Administrative Design Review Recommendation Packet

PROJECT ADDRESS:
9135 50th Ave S
Seattle, WA 98118
PN# 3034446-LU
February 14, 2025

DESIGN GUIDANCE RESPONSES

RESPONSE TO SDCI DESIGN GUIDANCE

PREFERRED OPTION—SITE LAYOUT AND DESCRIPTION

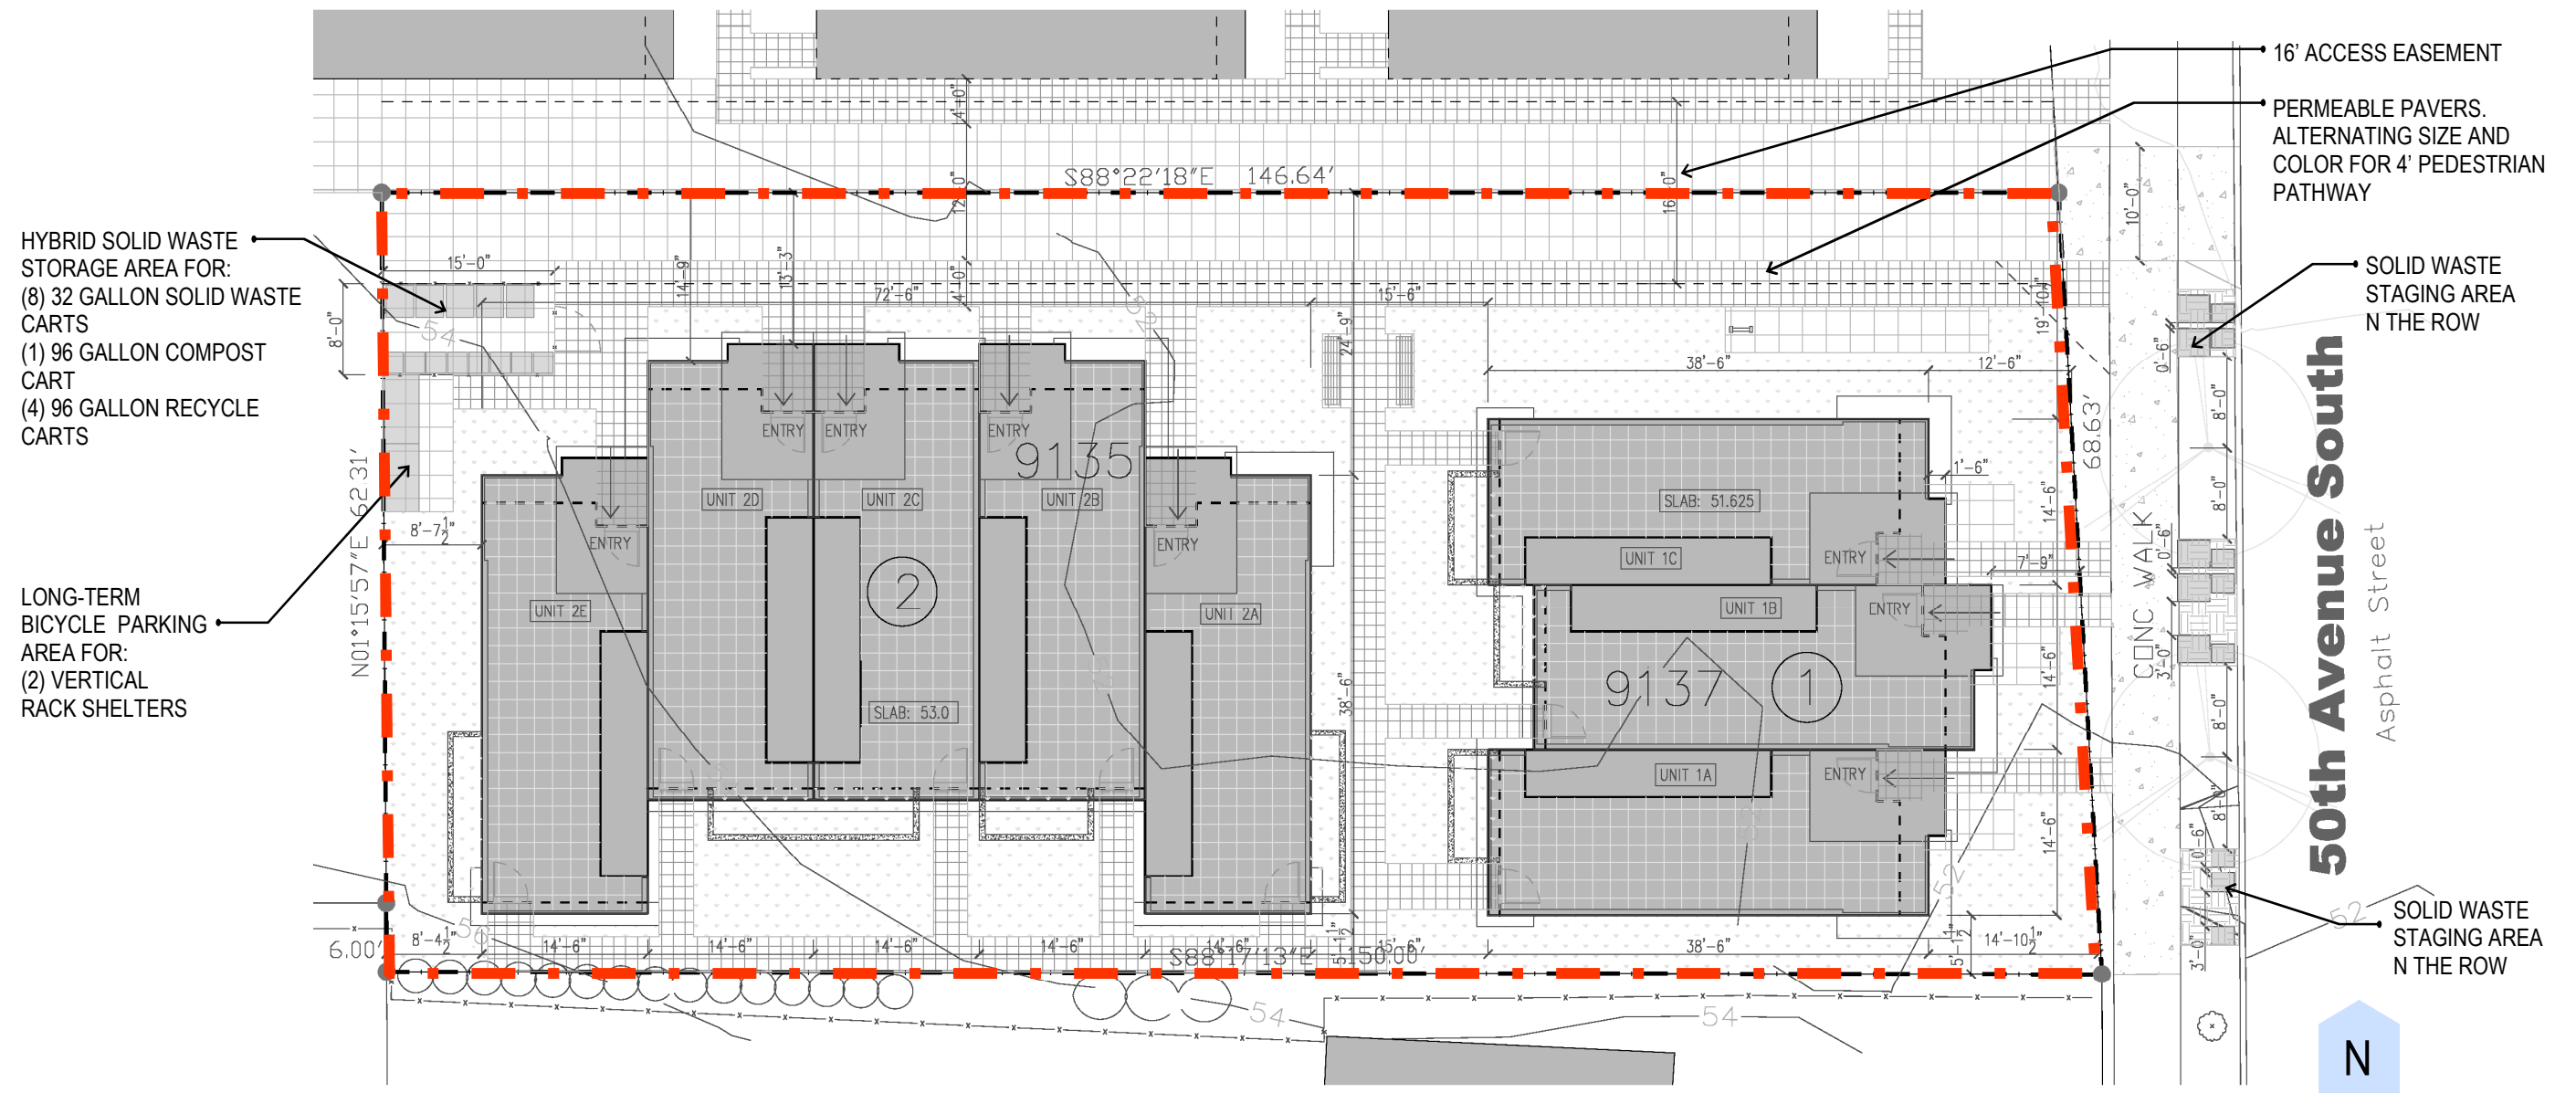
1. ARCHITECTURAL CONCEPT AND RESPONSE TO CONTEXT:

CS1-C, CS2-D, CS3-A-4 & DC2-A-1 –

3. STREETScape AND CONNECTION TO THE STREET

CS2-B-2, DC2-B-2, DC1-C-2, DC1-C-4, DC2-D, DC4-A, DC4-B, PL1-B-3, & PL3 –

4. PUBLIC LIFE, OPEN SPACE CONCEPT AND LANDSCAPING

CS1-B-2, DC2-D, DC3-B-1, DC3-B-4, DC3-C-2, DC4-D, PL1-B, & PL2-B

- c. PROPOSAL WAS UPDATED TO PROVIDE INDIVIDUAL ENTRY PATHWAYS TO THE STREET FRONTING BUILDING. PATIO AREAS WERE ADDED ABUTTING THE ENTRY PATHWAYS, LARGE ENOUGH FOR CAFÉ STYLE SEATING. SHARED PEDESTRIAN PATHWAYS TO THE OTHER BUILDINGS WILL ENCOURAGE OCCUPANTS TO INTERACT AND ENGAGE. YEAR-ROUND LANDSCAPING AND SEASONAL PLANTINGS WILL ADD VISUALLY APPEALING BACK DROPS. BIO-RETENTION PLANTERS ARE NOT ABOVE GROUND, THEREFORE THERE WON’T BE AN OVER ABUNDANCE OF CONCRETE. THE DRIVEWAY IS PROPOSED TO BE COMPRISED OF PERMEABLE PAVERS. THE PEDESTRIAN PATHWAY WILL BE DIFFERENTIATED FROM THE VEHICULAR PORTION WITH A CHANGE IN COLOR AND SIZE OF PAVERS.

- d. LANDSCAPING IS PROPOSED BETWEEN THE STRUCTURES AND THE STREET, ON THE EAST SIDE, RATHER THAN AN OPAQUE CEDAR FENCE.
- e. SOLID WASTE STORAGE AND STAGING HAS BEEN COORDINATED WITH SPU. A HYBRID SERVICE WILL BE UTILIZED TO REDUCE THE NUMBER OF CARTS STAGED IN THE ROW, AND STORAGE IS LOCATED AT THE REAR OF THE LOT, IN ITS OWN FENCED ENCLOSURE.

- a. THE ENTRY PATHWAYS FOR THE STREET FRONTING BUILDING HAVE BEEN REVISED TO PROVIDE INDIVIDUAL PATHWAYS TO EACH UNIT. LANDSCAPING HAS BEEN ADDED, WHERE PATHWAYS ONCE WERE.

- b. ALTHOUGH WE UNDERSTAND YOUR REQUEST FOR THE DIFFERENTIATED PEDESTRIAN PATHWAY TO BE ELEVATED FROM THE VEHICULAR PORTION, IT IS NOT FEASIBLE DUE TO OUR REQUIRED 16’ WIDE ACCESS EASEMENT. THE LAND USE CODE DOES ALLOW FOR A PEDESTRIAN PATHWAY TO BE PART OF A DRIVEWAY AS LONG AS IT’S DIFFERENTIATED IN COLOR AND SCALE.

- e. TREES HAVE BEEN INCORPORATED INTO THE LANDSCAPING ADJACENT THE DRIVEWAY.
- f. THE TREATMENT AND MATERIALS AT THE STREET FACING FACADES HAS BEEN UPDATED TO REFLECT A VISUALLY APPEALING AND USEFUL HUMAN-SCALE. PLANTINGS AND AMENITY SPACES ARE INVITING AND ENGAGING. THE SPACE BETWEEN THE BUILDINGS HAS BEEN DESIGNATED AS COMMON, WITH A SHARED PEDESTRIAN ACCESS PATHWAY. NEIGHBORS CAN CONGREGATE IN THESE FULLY ILLUMINATED AND LANDSCAPED AREAS.
